U.S. NUCLEAR REGULATORY COMMISSION
REGION I

Report No. 87-12

Facility Name: Beaver Valley Power Station, Unit No. 2

Inspection Summary:
Inspection on February 9 - 14, 1987 (Inspection Report No. 50-412/87-12).

TOTAL TIME LEAKAGE VS. TIME

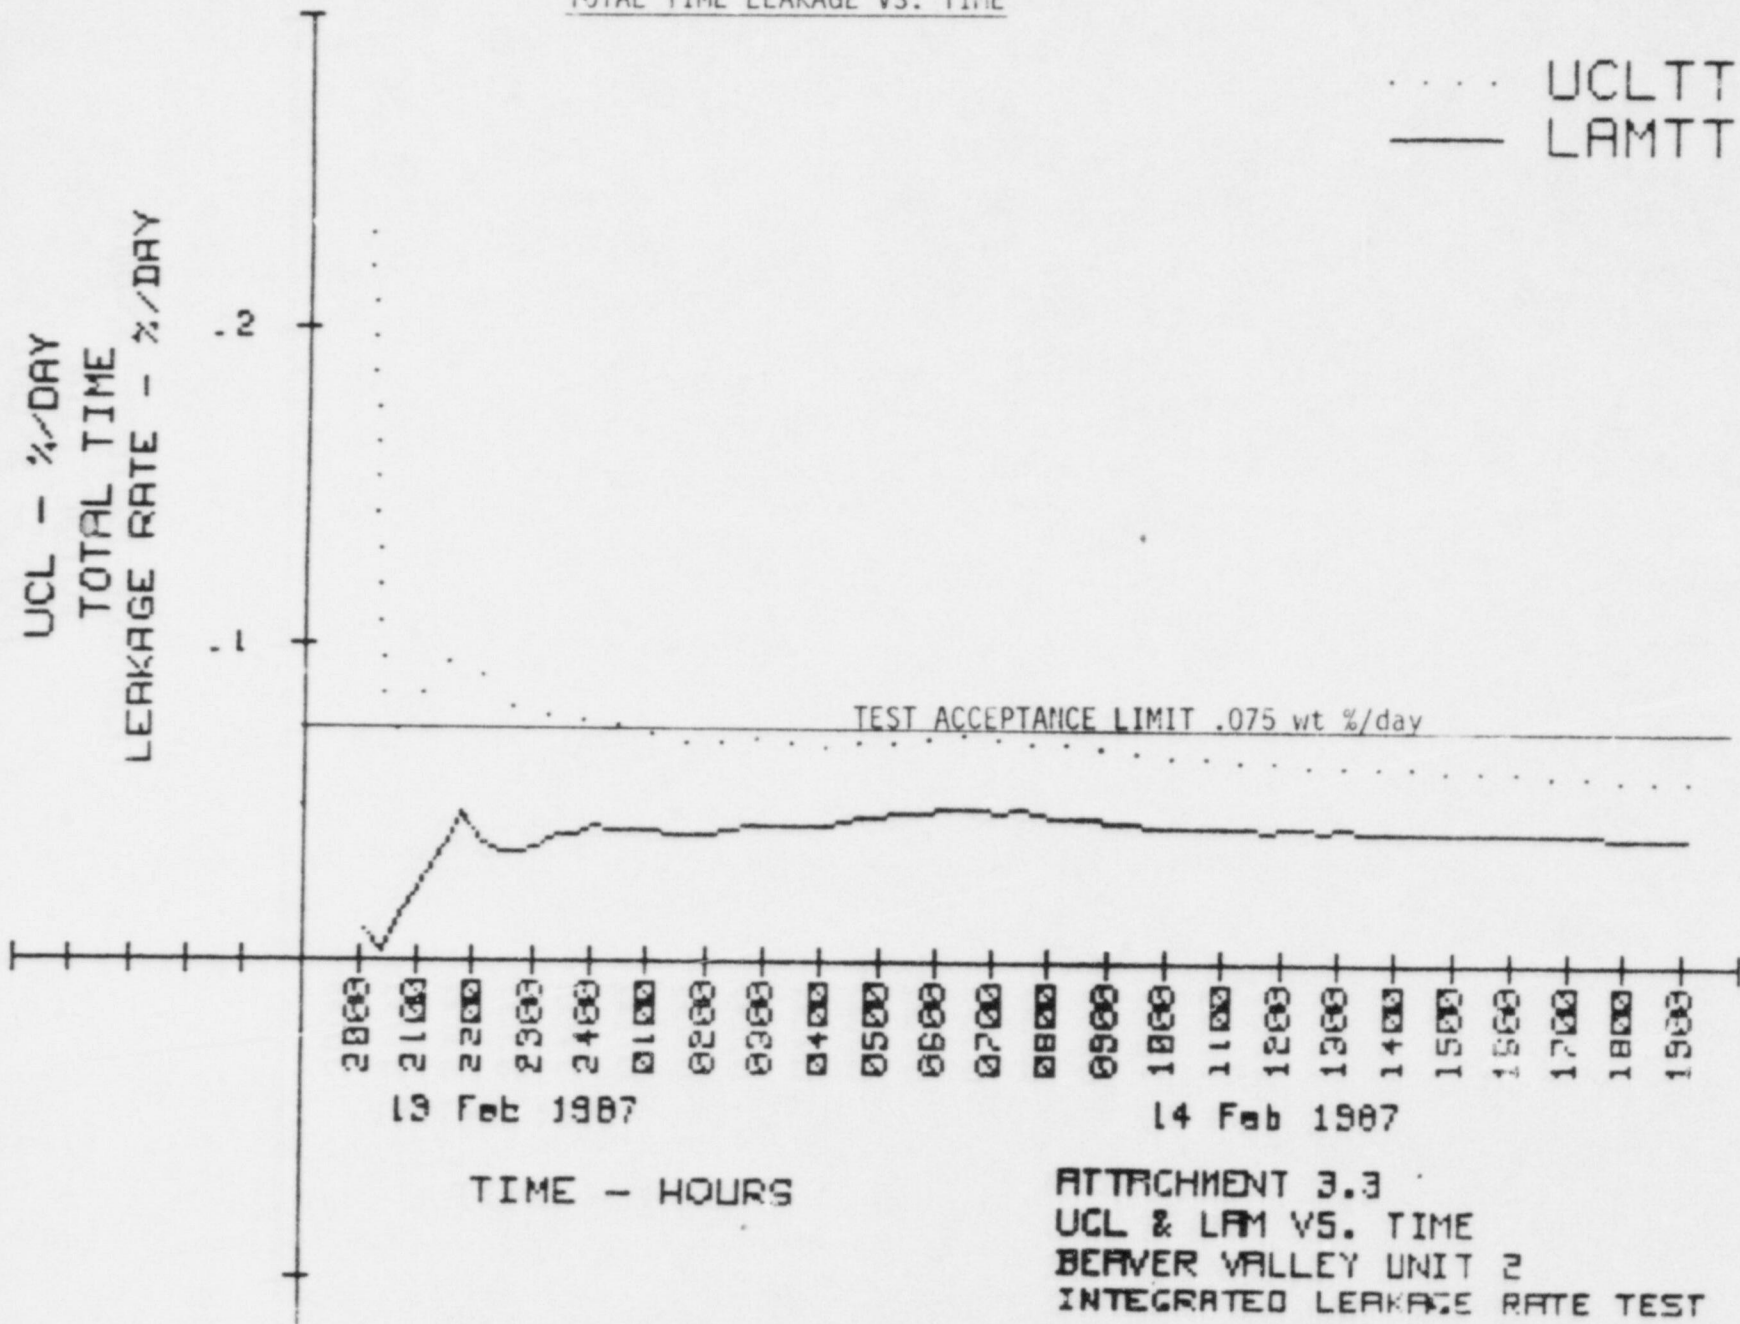
The licensee and NRC Computations were in good agreement. The results initially indicate a successful CILRT. Note that the inspector did not independently calculate the corrections for Type B & C leakage. A plot of the leakage trend may be seen on Attachment 2. The results are subject to additional "as-left" local leakage from recirculation spray system valve No. 2RSS*V4 and the recirculation spray system B header, which were isolated for the test due to leakage. A final test evaluation is pending NRC review of the licensee's summary technical report. This will remain an open Item No. 87-12-01.
